COUNCIL MEETING

ITEM	SUBJECT	PAGE NO
4	PLANNING & ENVIRONMENT	
4.2	Municipal Heritage Review - Stage 4 Places in Western Port and Hinterland Region (Area 4) and Stage 5 - Other Places (Watchlist)	
Attachment 1	Redacted Submissions (Part 1 of 2)	3

Mornington Peninsula Heritage Review Area 4: Western Port and Hinterland

Plan showing subdivision of Wrou's combined holdings – subject allotment dashed (Source: Certificate of title, vol. 8121, folio 096)

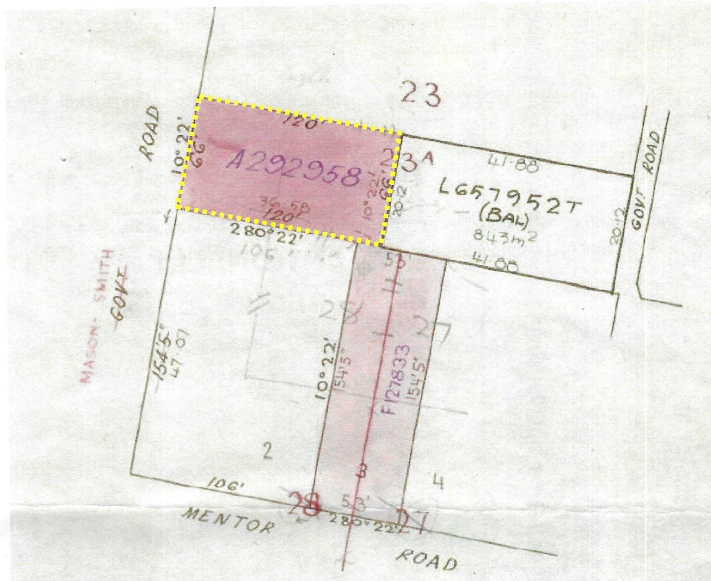
I think the Roberts → check John Wrou's plans

Simple Layout: 1930's

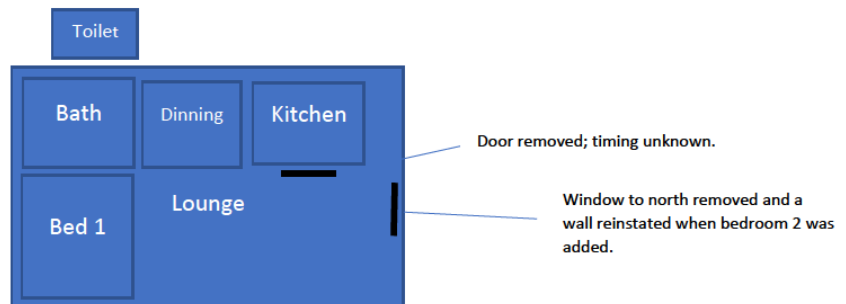
Based on the roof and floor structure the original building was a central rectangle with a pitched roof.

None of the original fabric is in place – the material is unknown. It is assumed the brick chimney, hardwood floor and wall studs are original. The chimney supports the lounge fireplace and must at some time had a wood stove in the kitchen. There is a structure for a doorway between the kitchen and the lounge (plastered over). There is also structure for additional windows (also plastered over) on the north wall of the lounge (this must have been done when bedroom 2 was added).

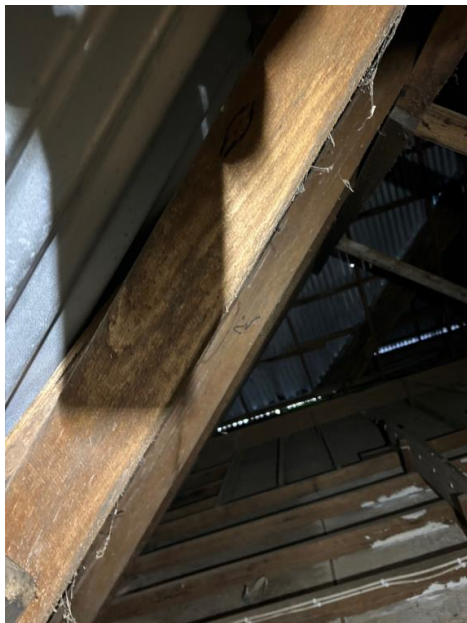
Roof Structure: The ceiling joists for Bed 2 and bed 3 have been constructed with a north south orientation whereas the original rectangle ceiling joists are were constructed with an east west orientation.

Notice bowing of the rafters -circa 50mm deflection.

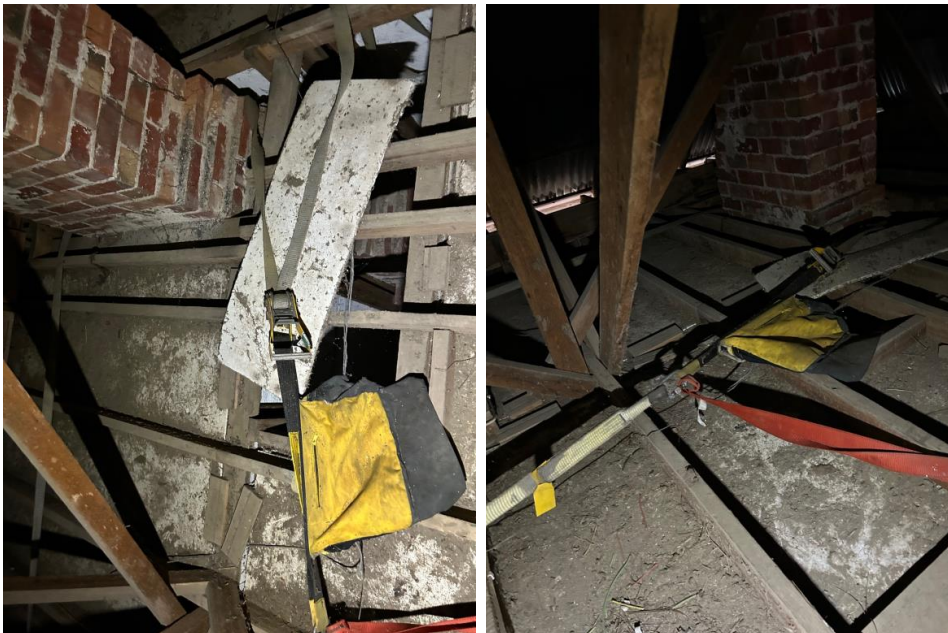
Additional bracing props to temporarily lock up the roof structure.

Ties and bolts were added post 2021 fire to temporarily tie the south Bed 3 addition to the central rectangle structure – these are very temporary. Significant water damage and the loss of the buildings stumps have resulted in the south addition separation from the original centre rectangle.

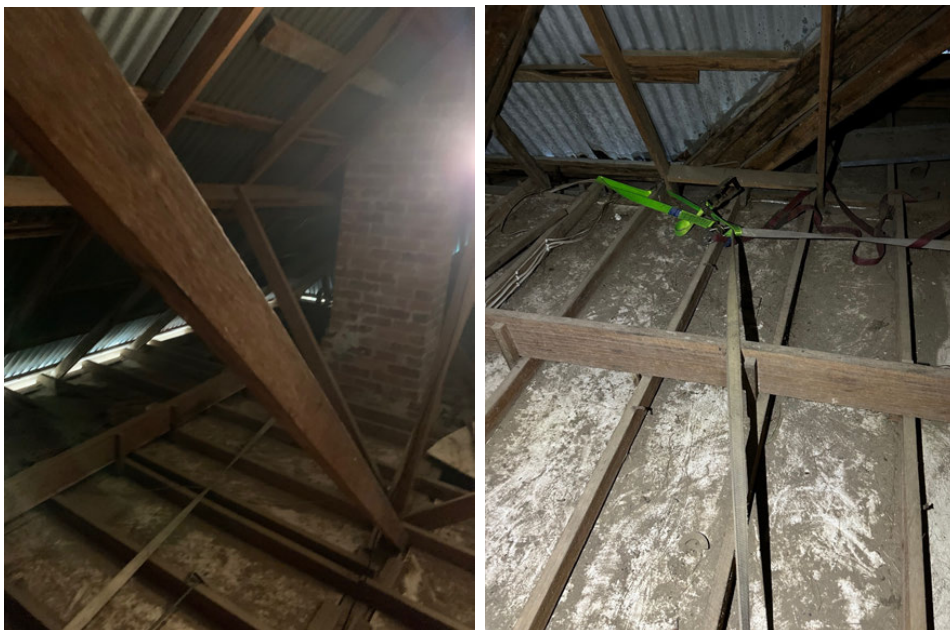
Additional bracing props to temporarily lock up the roof structure.

Ties and bolts were added post 2021 fire to temporarily tie the south Bed 3 addition to the central rectangle structure – these are very temporary. Significant water damage and the loss of the buildings stumps have resulted in the south addition separation from the original centre rectangle.
